Final Drainage Report  
for  
**Rolling Hills Ranch North Filing 1**  
at  
**Meridian Ranch**

April 2024

PCD Project No. SF-XXXX

FIGURE 8

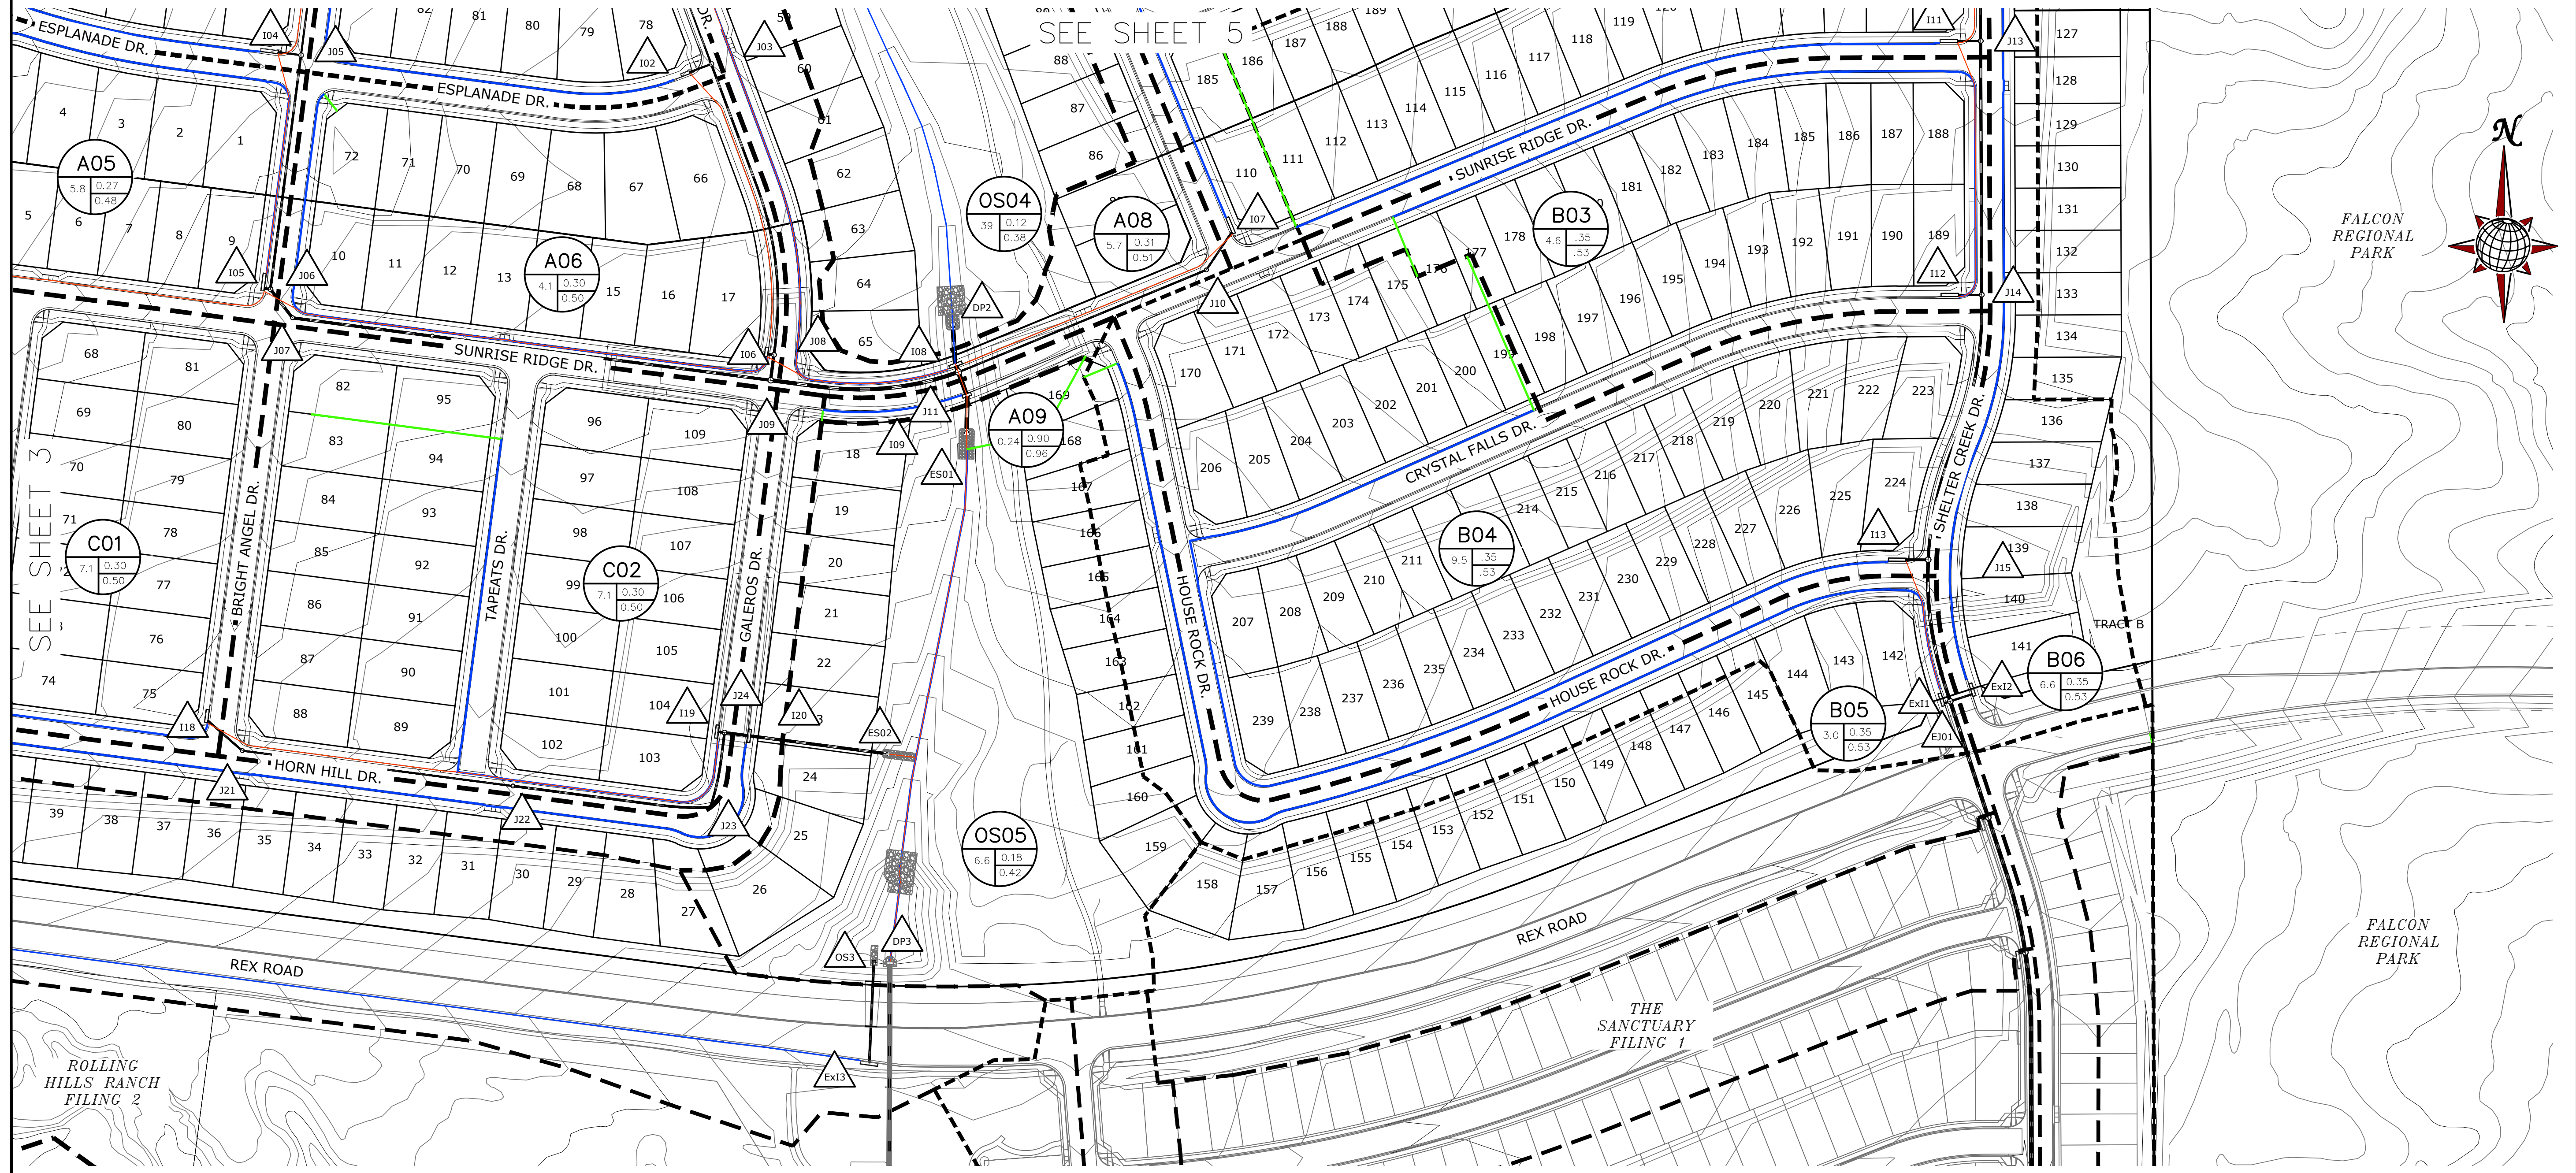
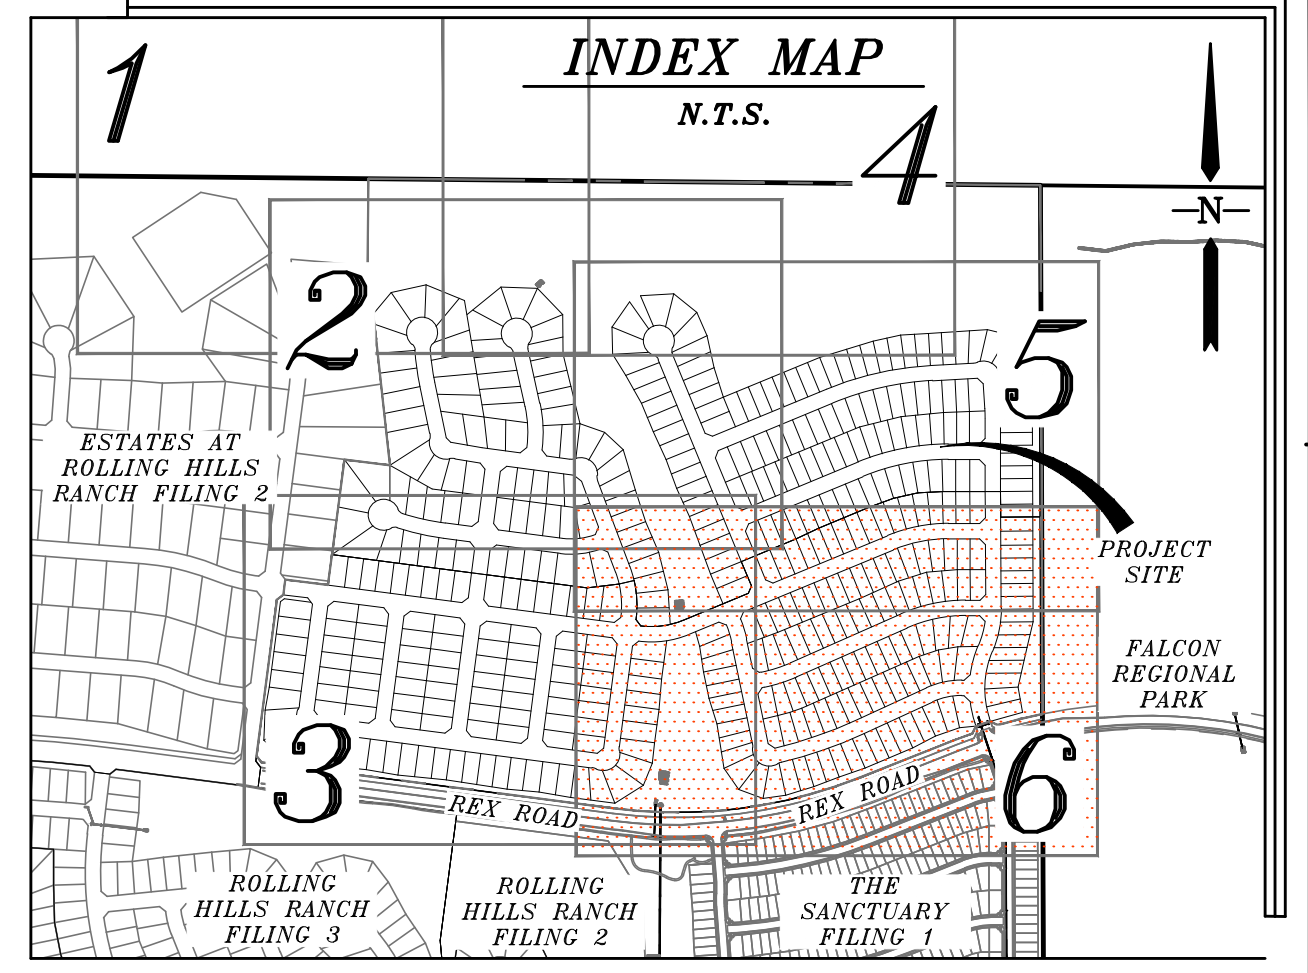
Please revise to flow for minor and major storms
